October 21, 2003  
NL-03-165

SUBJECT: Indian Point Nuclear Generating Unit No. 2  
Docket No. 50-247  
**Proposed Change to Technical Specifications:  
One-Time Change to the Indian Point 2 Steam  
Generator Tube Inspection Requirements**

**ENTERGY NUCLEAR OPERATIONS, INC.  
INDIAN POINT NUCLEAR GENERATING UNIT NO. 2  
DOCKET NO. 50-247**

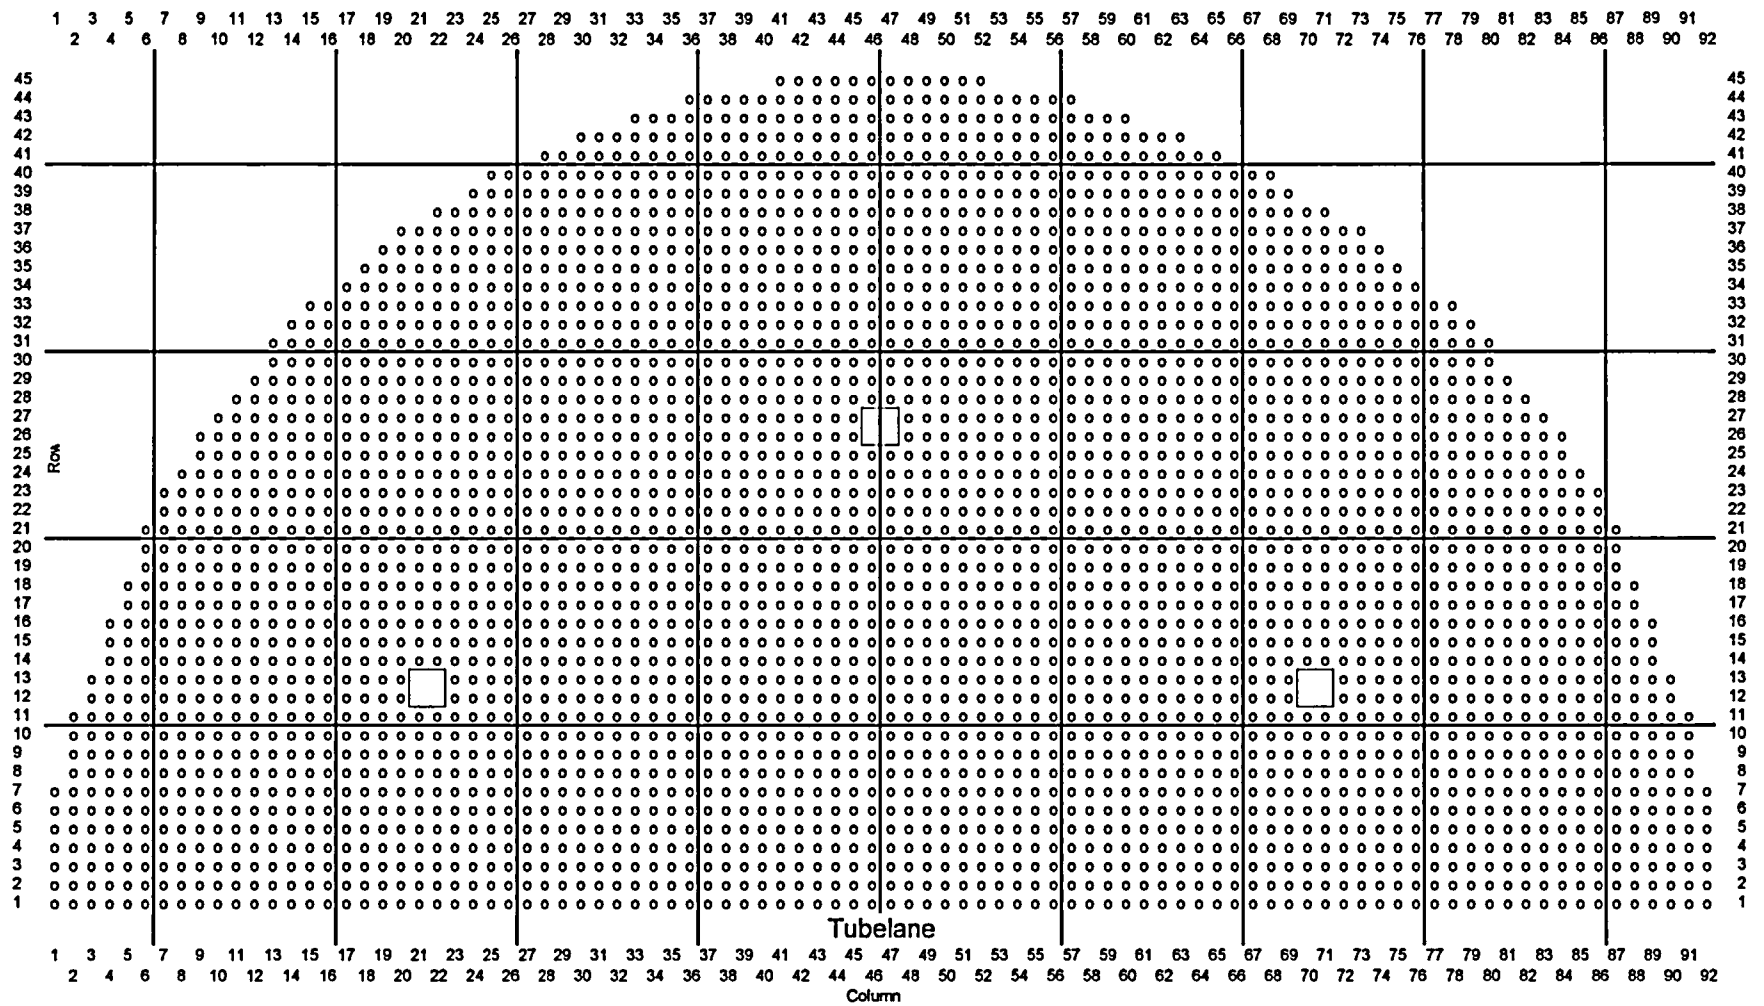
Several nuclear plants that have replaced steam generators recently, have requested extensions of their SG inspections intervals from 24 months to 40 months, after one C-1 classification. The plants that have requested this type of extension and have received NRC approval include Braidwood 1, Farley 1 and 2, South Texas Project, and ANO-2.
